Project Name | BCWD Permit 22-18 Stillwater Oaks**Date** | 09/08/2023**To / Contact info** | BCWD Board of Managers**Cc / Contact info** | Jason Palmby, Fairway Estates of Grant / Scott Dahlke, Civil Engineering Site Design**Cc / Contact info** | Karen Kill, Administrator / BCWD**From / Contact info** | Camilla Correll, PE; Ryan Fleming, PE; Paul Nation, PE; John Sarafolean / EOR**Regarding** | Permit Application No. 22-18 Engineer's Report

Applicant: Jason Palmby, Fairway Estates of Grant**Permit Submittal Date:** 7/26/2023**Completeness Determination:** 08/01/2023**Board Action Required By:** 09/30/2023**Review based on BCWD Rules effective April 1, 2020****Recommendation: Consider Variance Request**

Figure 3 - Proposed discharge to BCT2

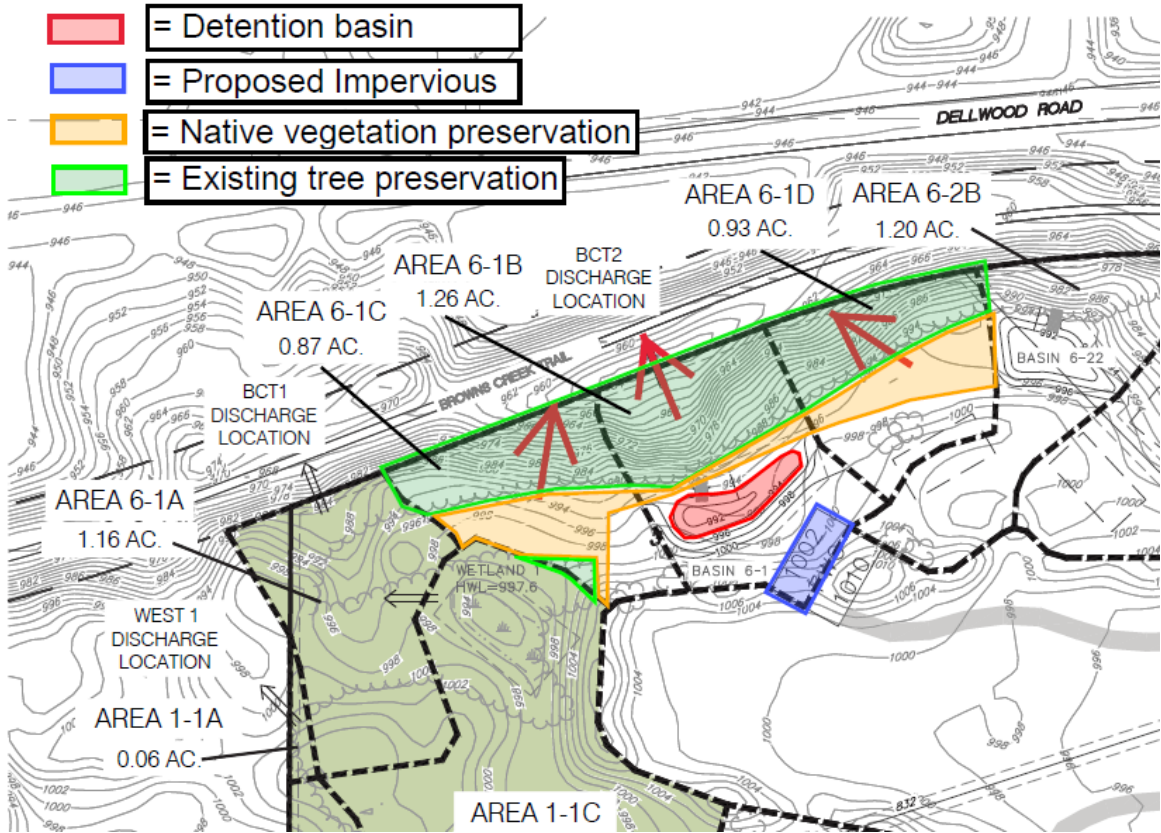
The applicant's variance request states that "Discharge volume increases over pre-settlement in areas where no impervious surface is proposed and volume control measures weren't feasible simply because the current landscape is not in a pre-settlement condition" and that "In drainage areas with development activity, some have increased volume and others have reduced volume depending on the suitability of the landscape for volume reduction practices." Two (2) discharge points have volumes that exceed the existing runoff volumes (BCT2, and BCT3) as outlined below.

- BCT2 - This discharge point collects drainage from three subcatchments including Area 6-1C, Area 6-1B and Area 6-1D. One of these subcatchments has new impervious coverage associated with the building pad as well as a rate control pond (Area 6-1B). A significant portion of the area is being converted to native vegetation; however, this area is downstream of the rate control pond where infiltration is infeasible due to soil conditions (Refer to Figure 3).
- BCT3 - This discharge point collects drainage from three subcatchments including Area 6-2B, 6-2C, and Area 6-2A. One of these subcatchments has new impervious coverage associated with the building pad. In addition, there are two rate control ponds in this drainage area that discharge to the native vegetation area (Refer to Figure 4).

The subtotals shown in Table 13 indicate locations of common drainage to a downstream resource, e.g., wetland or property. The BCWD engineer finds that there is sufficient data and analysis to support the board's granting the variance from the volume control requirement since the stormwater management plan demonstrates that more volume control is being provided at each of the subtotaled discharge locations than what is currently happening under existing conditions. While two of the discharge points along the vegetated swale (conveyance system) along Brown's Creek State Trail are increasing in volume from existing conditions, there are multiple discharge points along the same conveyance system that discharge less than existing conditions, so that the net discharge at the most downstream end is less than existing conditions overall by 13,786 cubic feet. Given that the net volume being discharged to the vegetated swale is less than existing conditions, there will be no impact to the vegetated swale. Additionally, there will be no impact to the downstream wetland system (as articulated under Rule 2.0). As a result of these evaluations, the BCWD engineer supports the board's granting a variance to the volume control requirement in this instance. Further, the total volume being mitigated via stormwater infiltration, stormwater reuse and evapotranspiration is greater than the volume currently leaving the site in total which also meets the District's goals for groundwater recharge and runoff reduction.
